BLOOMINGTON CIVIC PLAZA SITE IMPROVEMENTS & FIRE STATION 3 CONCRETE REPAIR

Reviewed for Code Compliance

Plan #: PRPK202504861

Construction Documents

C-200

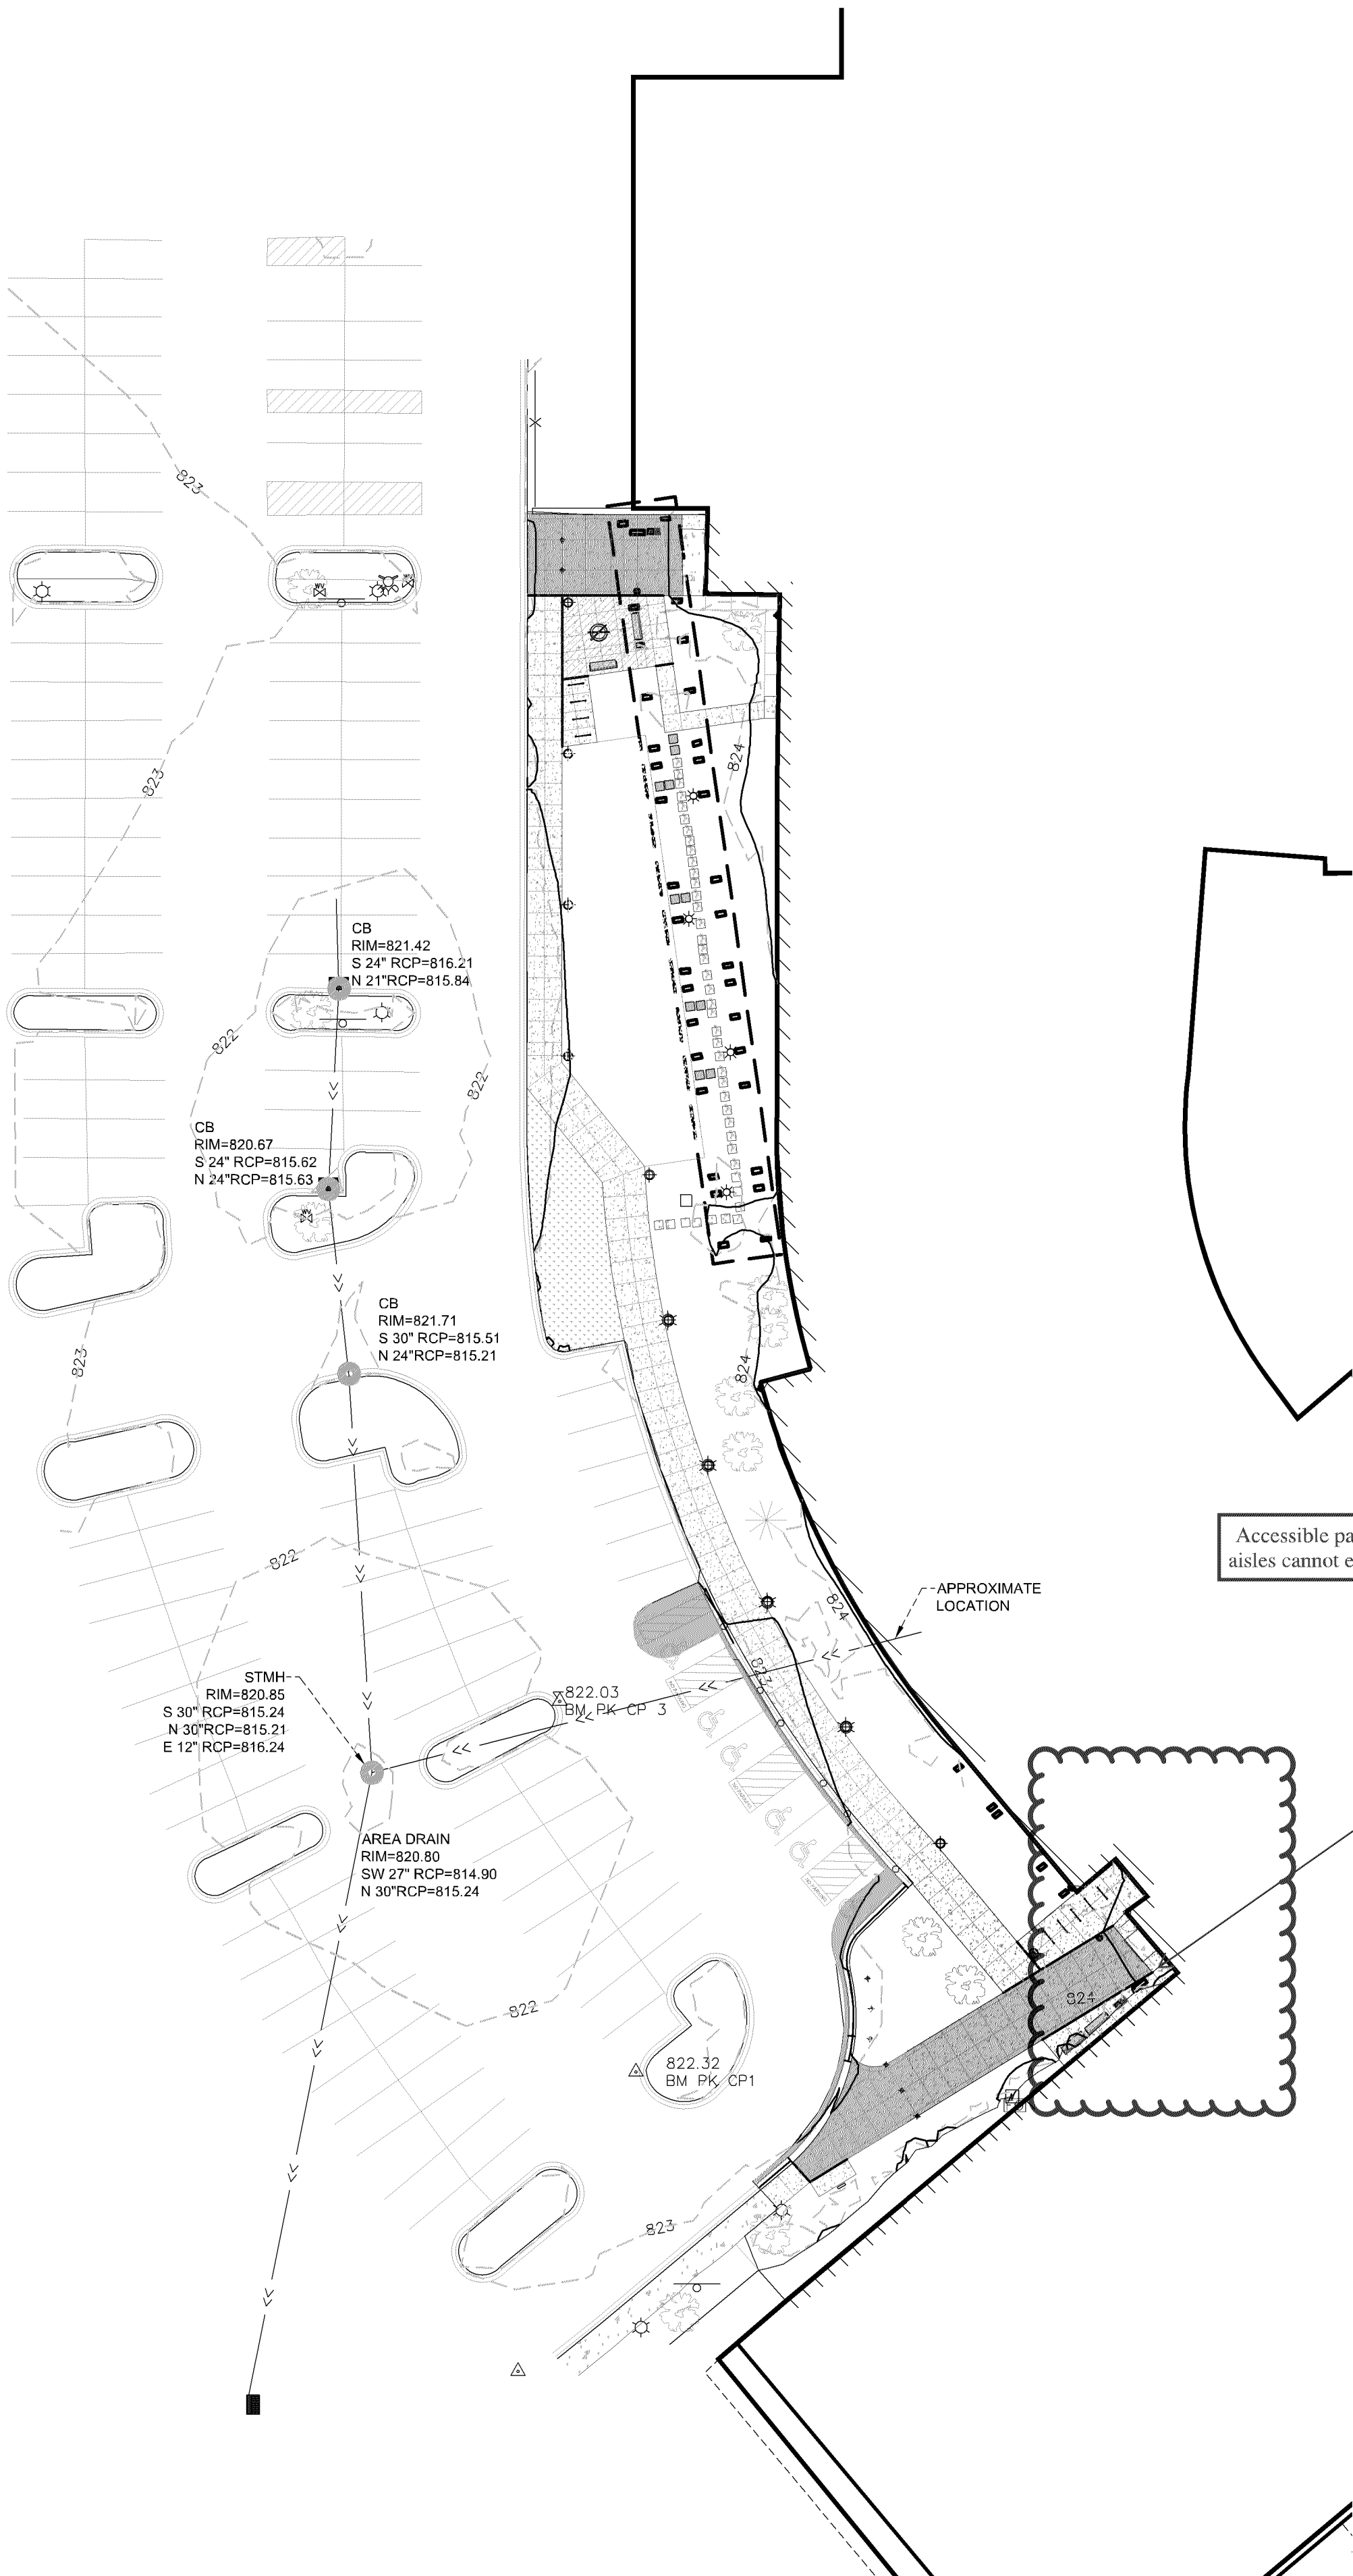
TABLE 404.2.3.3 MANEUVERING CLEARANCES AT SLIDING AND FOLDING DOORS		
APPROACH DIRECTION	MINIMUM MANEUVERING CLEARANCES	
	Perpendicular to Doorway	Parallel to Doorway (beyond stop or latch side unless noted)
From front	48 inches (1220 mm)	0 inches (0 mm)
From nonlatch side	42 inches (1065 mm)	22 inches (560 mm)
From latch side	42 inches (1065 mm)	24 inches (610 mm)

"NO PARKING" SIGN REQUIRED:

Access Aisles shall be marked with a sign to discourage parking in them. The "no parking" designation shall be provided on a sign centered at the head of the access aisle and maximum of 96" from the access aisle, and be mounted 60"-66" above the floor of the access aisle.

(MAC 502.4)

Accessible route from access aisles to the entrance doors:

Walking surfaces shall be no steeper than 1:20, with a cross slope no more than 1:48. The clear width of accessible route shall be 48" min. (MAC 403, & 403.5.4)

Landing in front of the sliding door must be a min of 48" for the entire door opening.
